Wisconsin Department of Transportation

Proposal #01: 1060-33-84, WISC 2020 466
Zoo IC, USH 45
Swan Blvd to Burleigh Street
USH 45
Milwaukee County

Letting of October 13, 2020

This is Addendum No. 03, which provides for the following:

Addendum No. 03
 ID 1060-33-84
 Revised Sheet 25
 September 24, 2020

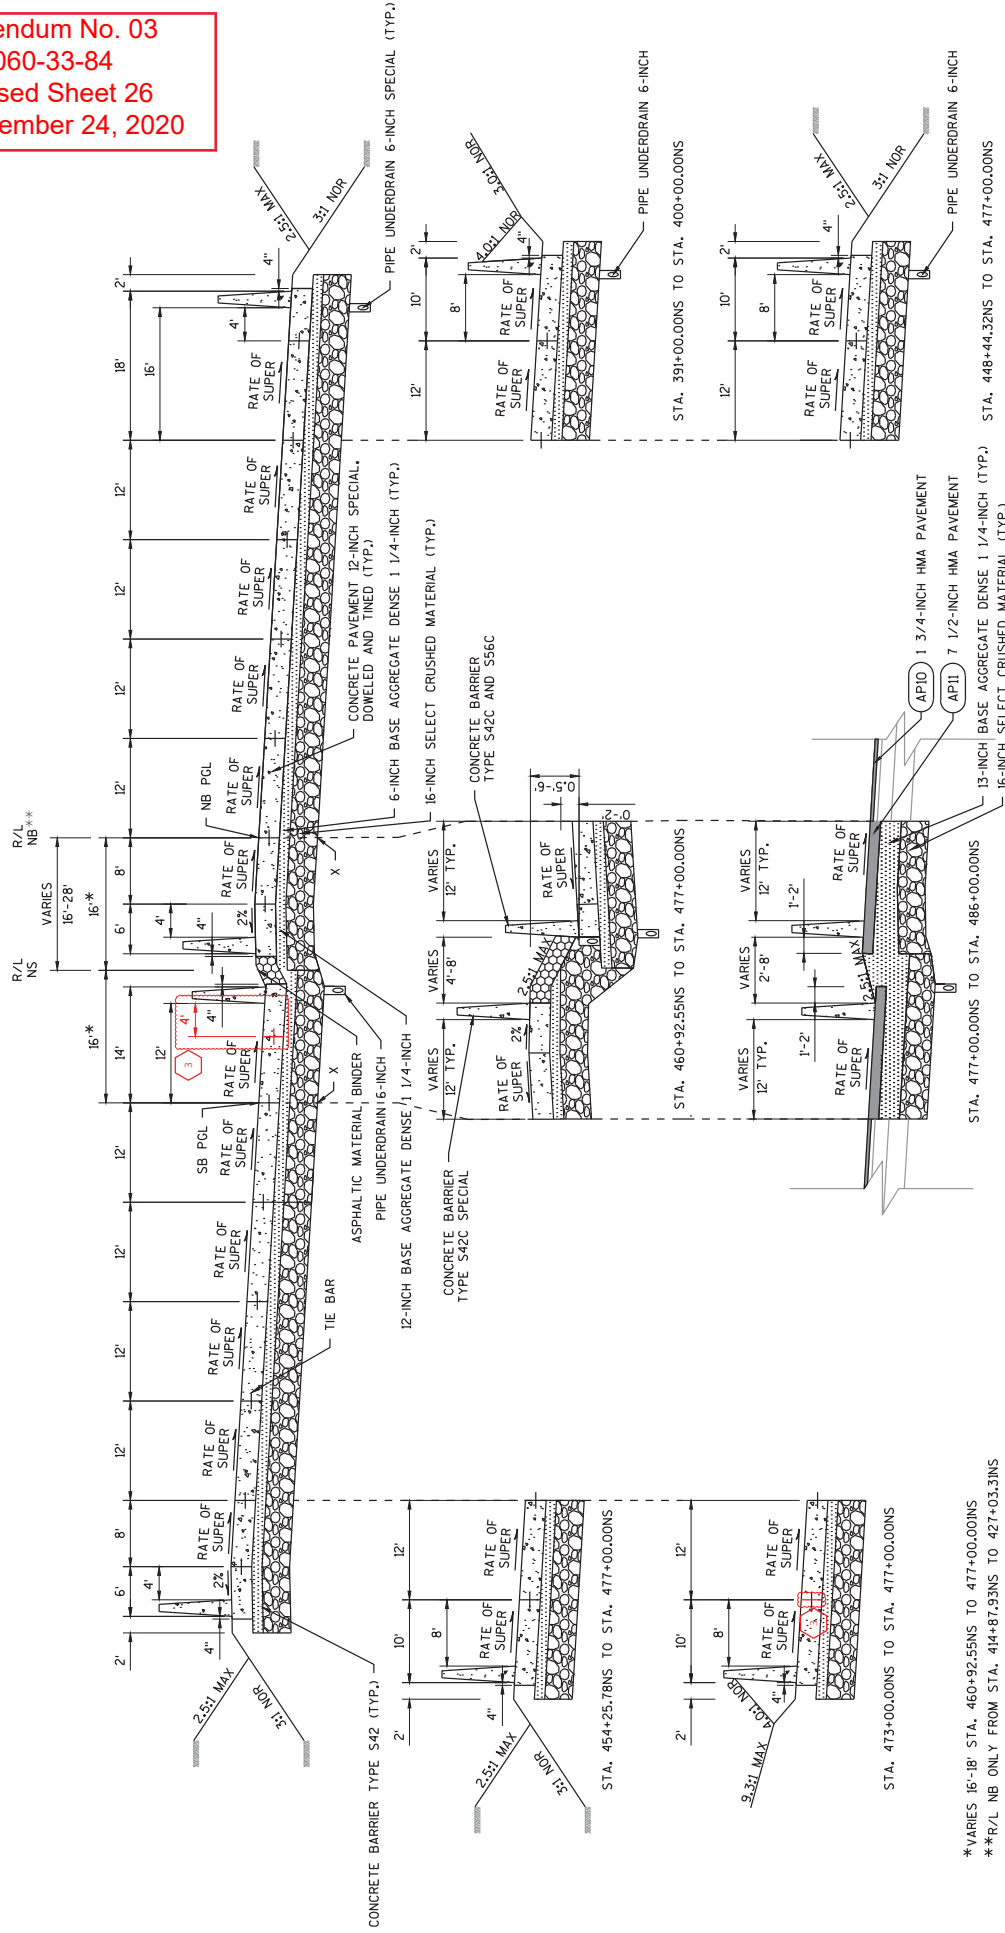
Revised Plan Sheets	
Plan Sheet	Plan Sheet Title (brief description of changes to sheet)
25	Typical Sections – Added labels, tie bars, and joints
26	Typical Sections – Added labels, tie bars, and joints
60	Construction Details – Revised HPC Pavement Joint Details
598	Lighting Plans – Update for Wauwatosa lighting
599	Lighting Plans – Update for Wauwatosa lighting
600	Lighting Plans – Update for Wauwatosa lighting
601	Lighting Plans – Update for Wauwatosa lighting
602	Lighting Plans – Update for Wauwatosa lighting
603	Lighting Plans – Update for Wauwatosa lighting
604	Lighting Plans – Update for Wauwatosa lighting
605	Lighting Plans – Update for Wauwatosa lighting
606	Lighting Plans – Update for Wauwatosa lighting
607	Lighting Plans – Update for Wauwatosa lighting
990	Miscellaneous Quantities – Revised Salvage Temporary Precast Concrete Barrier Left In Place quantity
1009	Miscellaneous Quantities – Updated the cross stitching table with locations

Addendum No. 03
 ID 1060-33-84
 Added Sheet 54A
 September 24, 2020

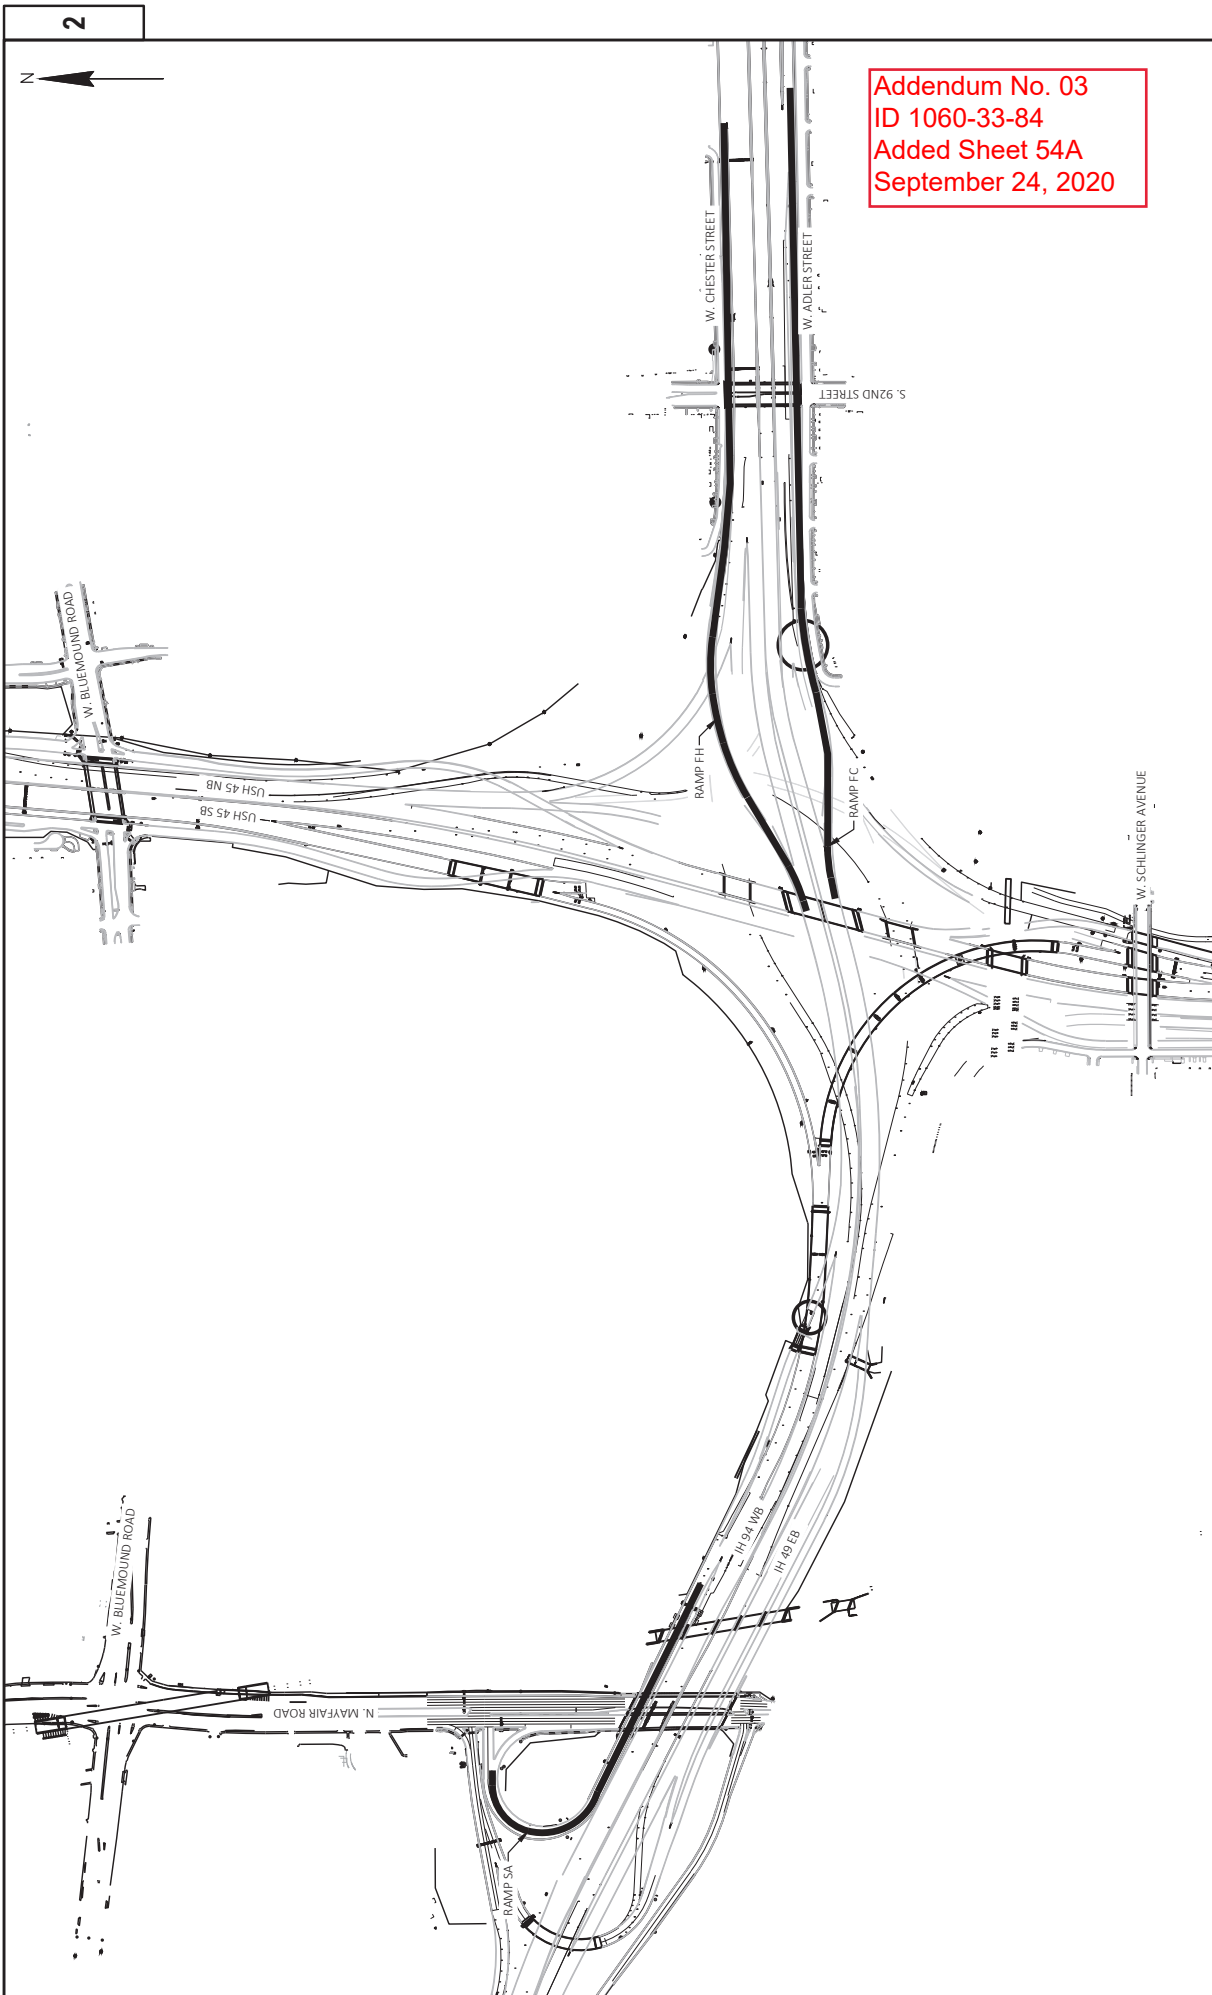
Added Plan Sheets	
Plan Sheet	Plan Sheet Title (brief description of why sheet was added)
54A	Construction Details – Cross-stitching locations
54B	Construction Details – Cross-stitching locations
60A	Construction Details – HPC Pavement Joint Details
545A	Lighting Details – Added Wauwatosa pole, wiring, and pull box detail
1422A	Add SDD Single Slope Roadside Retaining Wall - Cross Section and Steel Details
1422B	Add SDD Single Slope Roadside Retaining Wall - Placement and Drainage
